Hi-Fi Products  
**Service Bulletin**

**Model:** TC-K620/K650ES

**No.156**

**Subject:** Capstan Motor Misoperation

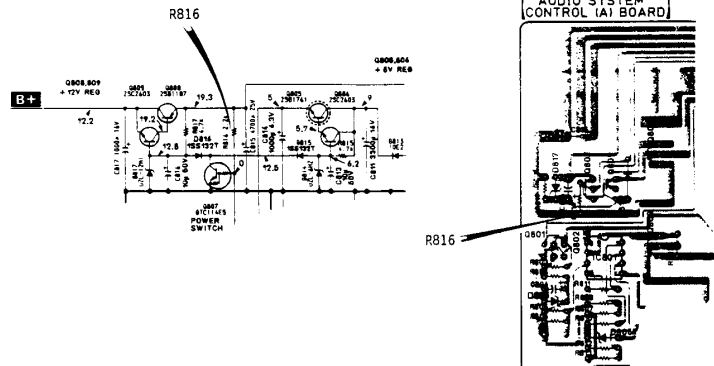
The capstan motor continues to rotate slowly and the cassette holder LED lights dimly after the power has been switched off.

**Cause:** The problem is due to the unstable switching of Q807.

**Solution:** If this symptom occurs, replace R816 as listed below:

Ref. No.	Description		Part Number
	Former	New	
R816	22k Ohm	4.7k Ohm	1-249-425-11
